**STAFF REPORT:** 02/11/2026 MEETING  
**APPLICATION NUMBER:** HDC2026-00002  
**ADDRESS:** 2310 EDISON

**PREPARED BY:** A. DYE

**SCOPE:** INSTALL NEW WOOD WINDOWS AT FRONT (FAÇADE)

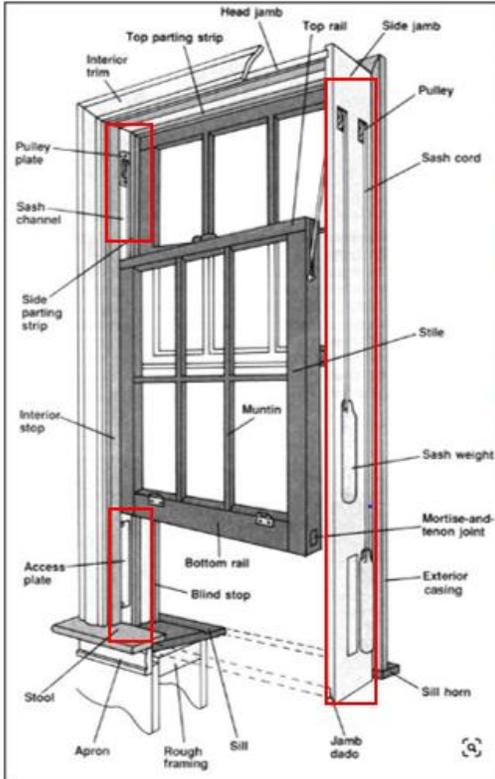
- The Boston Edison Historic District was enacted on April 2, 1974.
- The designation photo documents most of the original windows on the front wall. The grouped window opening at the first floor consisted of six narrow 18-lite (3-wide by 6-high) casement units with lead comes. The double-hung windows at the second floor had vertically divided multi-paned upper sash over single glass lower sash and the third floor/attic window was a nine-paned window. The uniquely patterned windows on the house were common designs for arts and crafts-style houses and are identified as distinctive character-defining features.
- The leaded glass windows on the façade at the first floor were replaced without Commission approval between 2011 and 2013, based on Google street view images. The remaining windows on the house were replaced in April 2024 with vinyl windows.

- July 10, 2024, HDC meeting - The Commission reviewed an application (HDC2024-00229) for the approval of the installed vinyl windows. That proposal was denied, as the historic window sashes had been intact, and the deteriorated conditions were determined to be repairable. The Commission requested the applicant put forward a proposal to repair and reinstall the historic windows and to return to a future Commission meeting. The Commission stated it may consider a multi-year proposal to return the openings to their previous condition.
- The Elements of Design for the Boston Edison Historic District discuss the importance and key features of windows and their significance to the appearance of the house and district:
